Amendment Report

Blind Creek Solar Farm

October 2022

Project Number: 22-319

Figure 1-2 Indicative layout and site constraints (as amended)

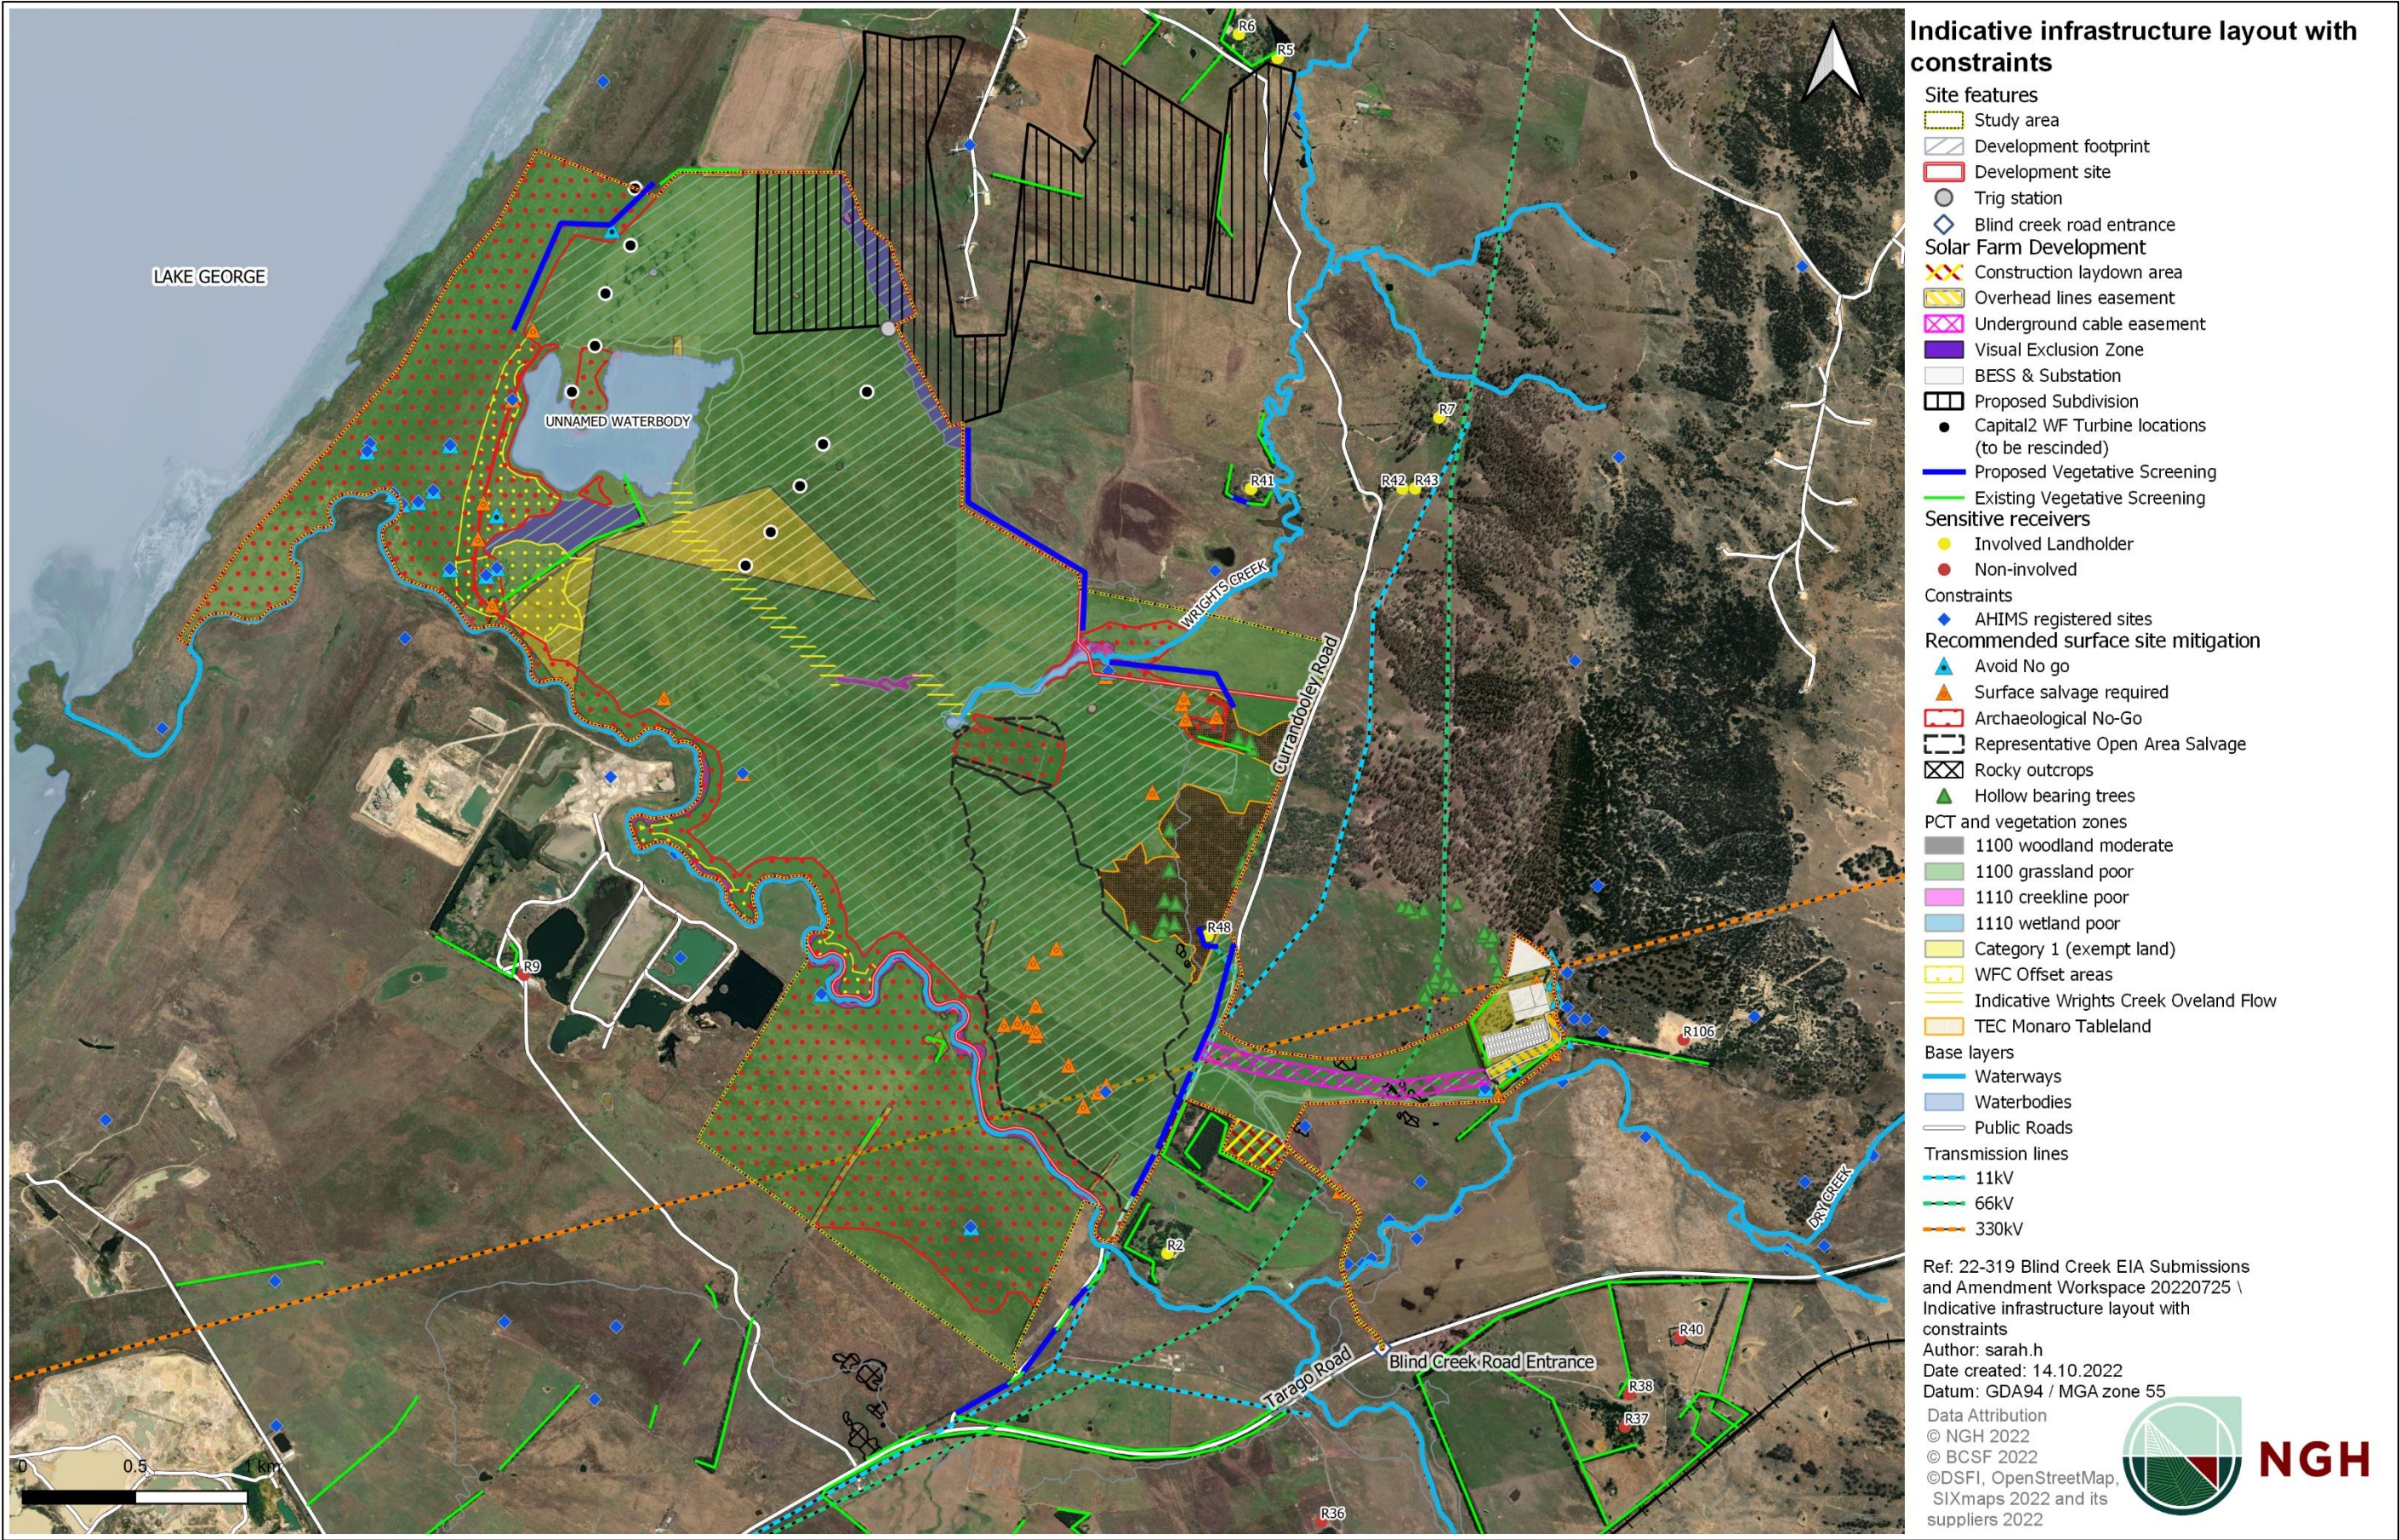
Refer to Table 1-1 and Figure 1-2 for a comparison of amendments to the Project and key site constraints.

- Provide a flow path for Wrights Creek, through the solar arrays to the identified wetland and beyond, which does not contain solar panels. This flow path is to be based on hydrology assessments to ensure the natural flow path is maintained in accordance with the Guidelines for Controlled Activities on Waterfront Land (NRAR 2018).
- The detailed design will take into consideration the Non-riparian corridor works and activities averaging rule, whereby 50% of the outer riparian zone would be used for development with an equivalent area connected to the riparian corridor fully offset. The inner 50% of the riparian zone will be offset.
- Subsurface access across the overland flow path will form a requirement of the Project.

An indicative flow path is shown in the Constraints Map (Figure 1-2) above.

Figure 2-1 Visual exclusion zone

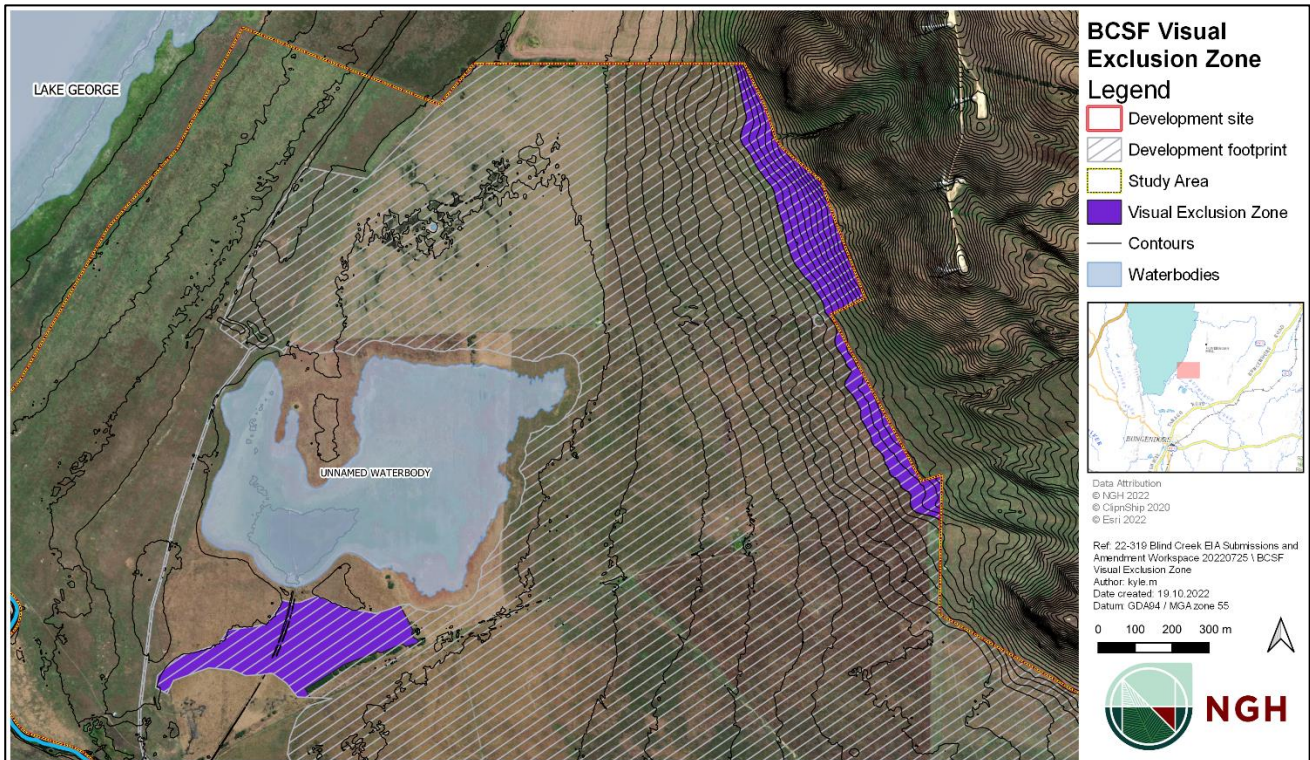
2.2.7. A commitment to exclude solar panels from elevated areas on Lot 17 DP535180 (above elevation 691m) to reduce visual impacts to receivers on Lake Road.

The Applicant has also made a commitment to reduce potential visual impacts from Lake Road (which overlooks the lake), by avoiding placing panels above the 691m contour line in areas within or bordering Lot 17//535180 and west of the established Elms between the wetland and Butmaroo Creek. Refer to Figure 2-1 below.

These amendments were proposed in consultation with landholders on Lake Road, with a view of Lake George.

Figure 2-2 Subdivision Plan

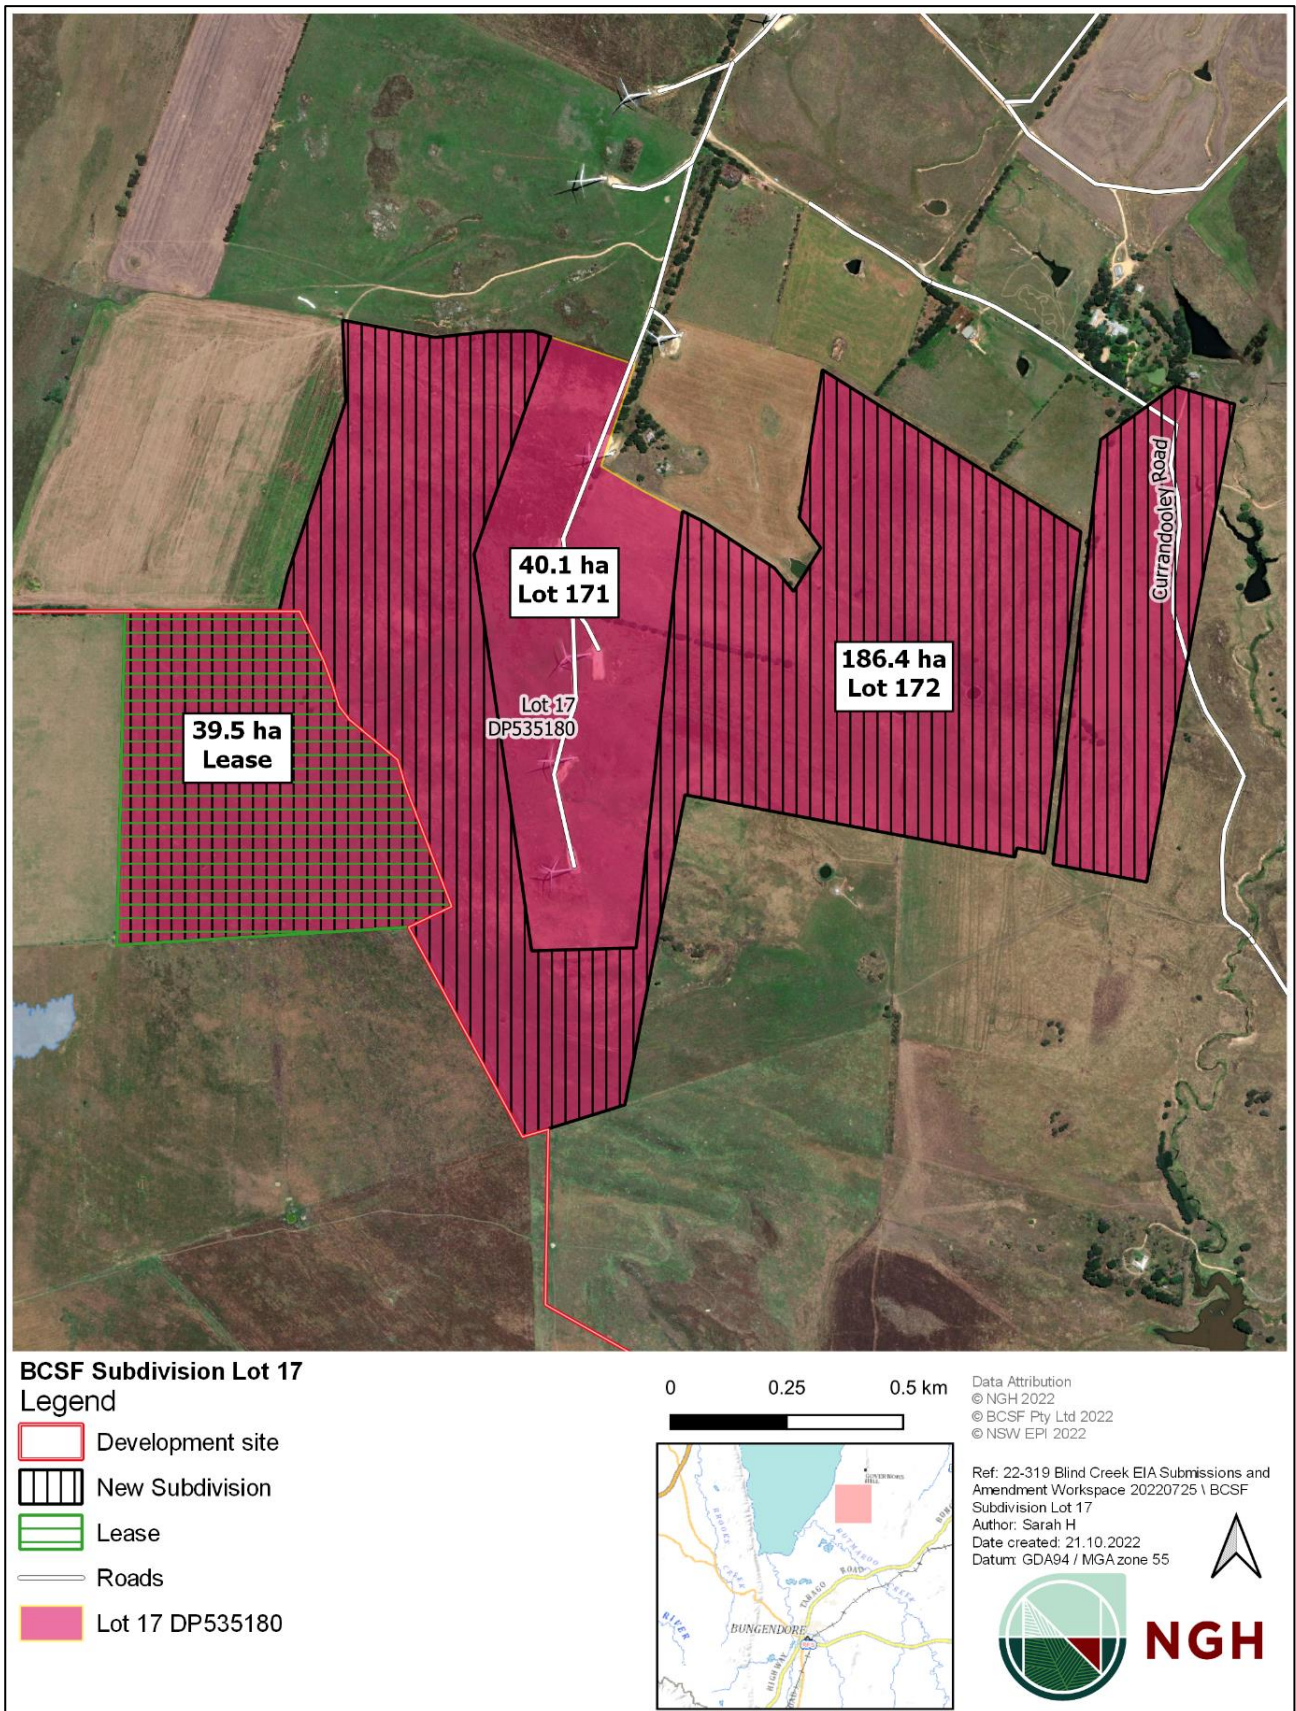
2.2.9. Change subdivision requirements

The subdivision plan in Figure 2-2 below and in Appendix E.7 shows Lot 17 DP 535180 to be subdivided into two lots, with the minimum lot size being greater than 40 hectares. As such, the subdivision is permitted with consent under the Palerang LEP. Pending approval of the Project, the subdivision would be administered through consultation with Queanbeyan-Palerang Regional Council.
